SUBJECT: Withdraws proposed license amend dtd 970904.RAI response to
TS change 96-10 included.

Subject: Oconee Nuclear Station
Docket Nos. 50-269, -270, -287
High Pressure Injection System Requirements
Response to Request For Additional Information
Technical Specification Change # 96-10

Attachment
Response to Request for Additional Information

UNIT 1 THERMAL SLEEVE

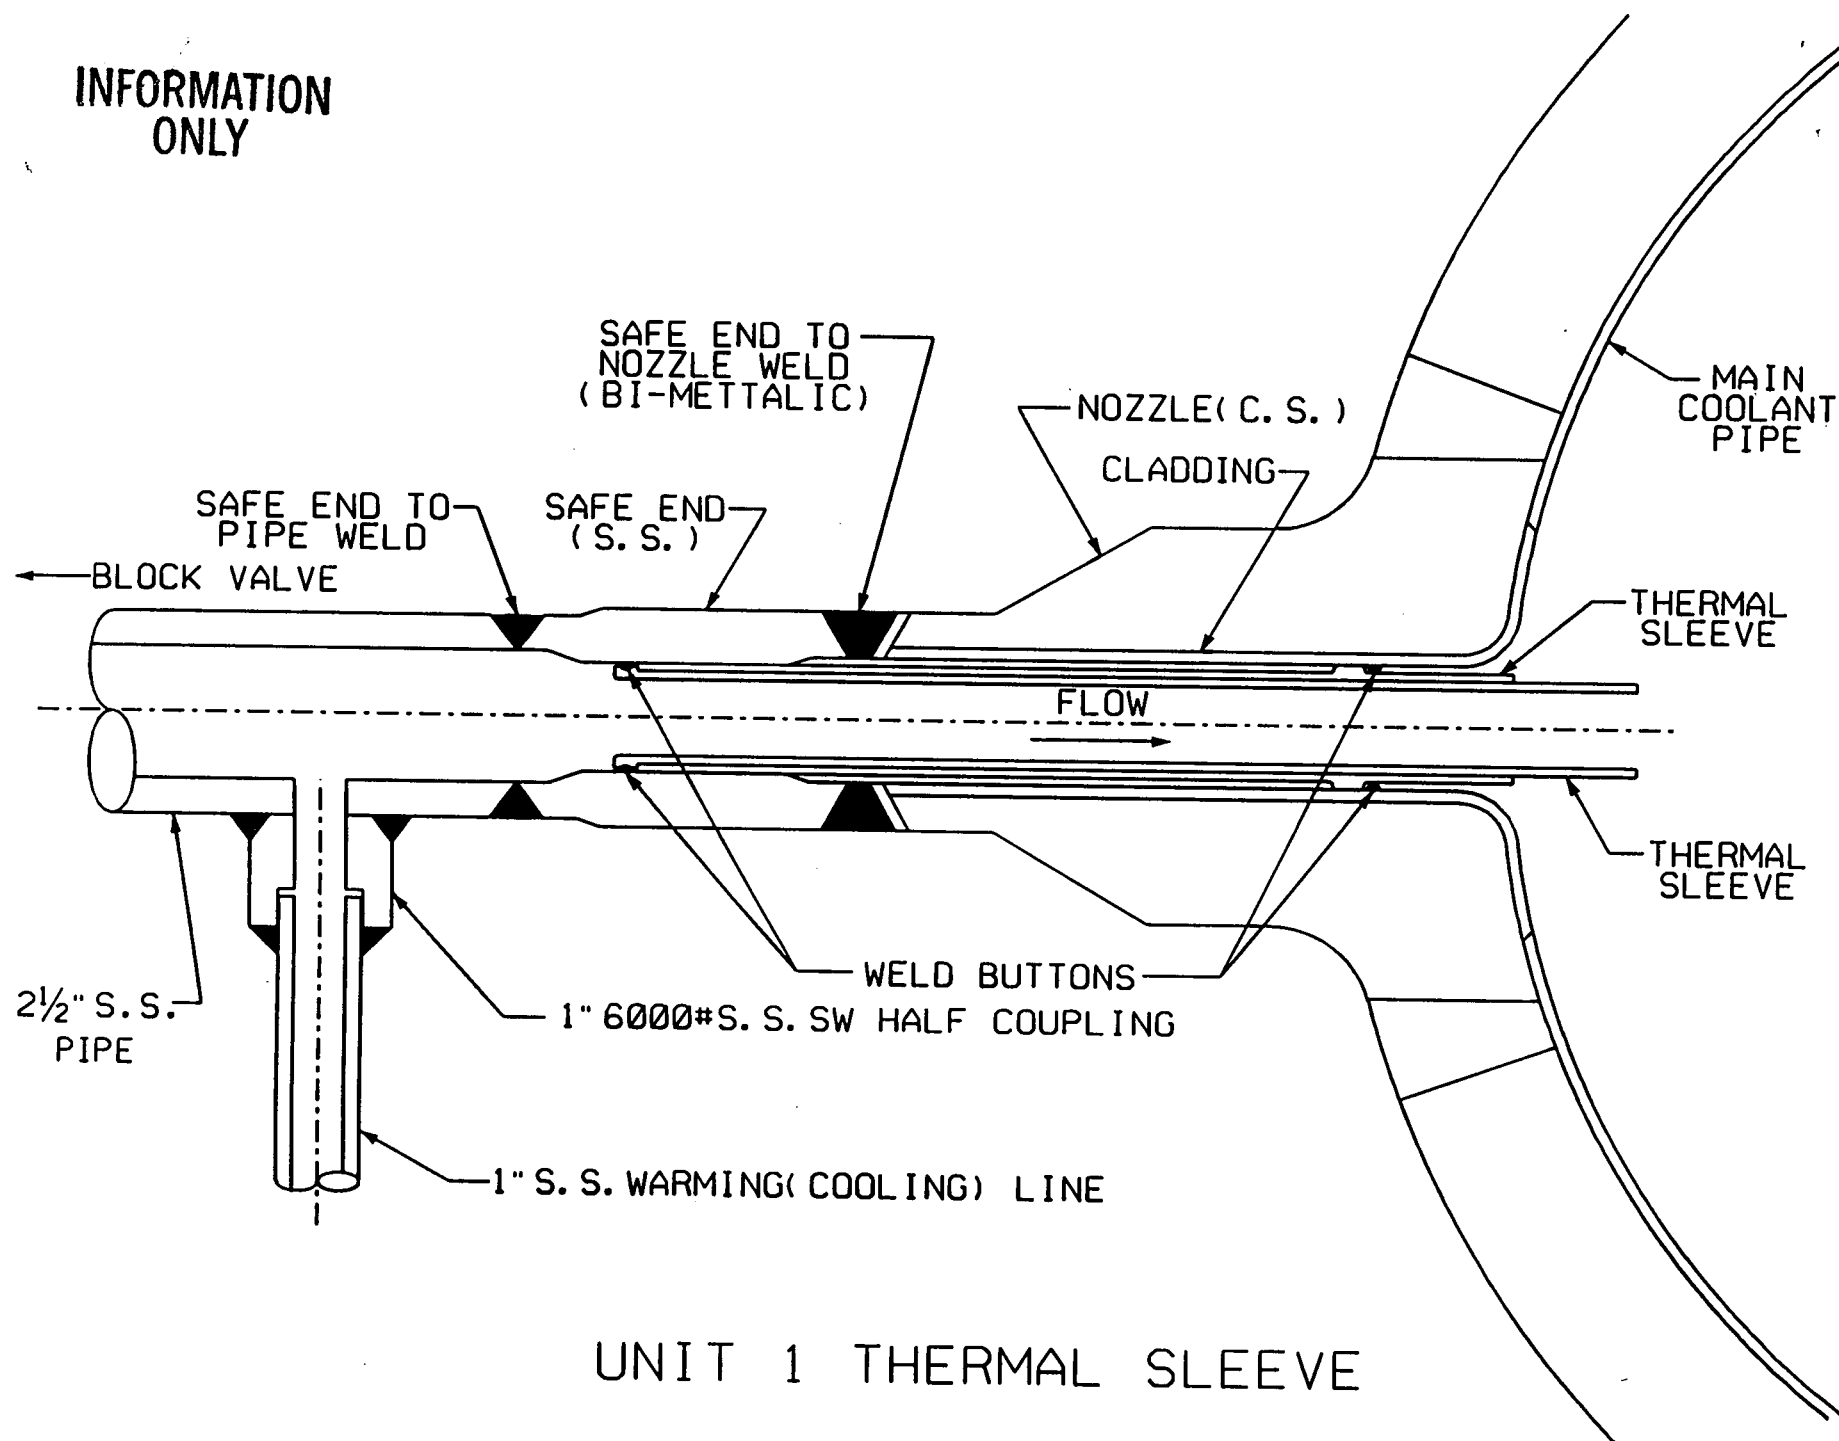
Question 5: You explain that the "HPI injection nozzle is not included in the break spectrum" in your submittal. Please provide greater detail and a drawing of what is and is not included in the break spectrum and then describe what break sizes and types are analyzed.

The SBLOCA break spectrum for B&W lowered-loop plants like Oconee has been established historically as the LOCA Evaluation Models and analyses have evolved. The current limiting SBLOCAs have been identified and confirmed by analyses as the cold leg pump discharge break (bottom of the pipe), the core flood line break, and the HPI line break. The limiting cold leg pump discharge break size is determined for each plant and set of assumptions by analyzing a sufficiently fine break spectrum. The limiting break size is identified by the highest PCT. Since the SBLOCA PCT has always remained well below the LBLOCA PCT, there has always been margin in the SBLOCA results for Oconee. The core flood line break and the HPI line break have been identified as special SBLOCA cases, at specific locations and with specific break sizes. The core flood line break (0.44 ft^2) corresponds to the inside diameter of the core flood nozzle insert that was installed to limit the break size. The limiting single failure and available ECCS equipment for the core flood line break are unique due to its specific location.

Similarly, the HPI line break (0.025 ft^2) corresponds to the inside diameter of the injection line where it connects to the nozzle on the cold leg. This break has unique ECCS performance due to the spilling of the HPI injection flow on the broken injection line, which results in a more adverse loss of ECCS flow. The submittal identified the established licensing position that a failure of the nozzle is not considered in the SBLOCA spectrum. Thus, break sizes greater than 0.025 ft^2 associated with the nozzle breaking

off the RCS and the affected HPI line being exposed to containment back pressure are not postulated. This position is shared by all B&W design plants. The submittal is not introducing any new licensing positions relative to the SBLOCA break spectrum. Drawings of the HPI nozzles are attached.
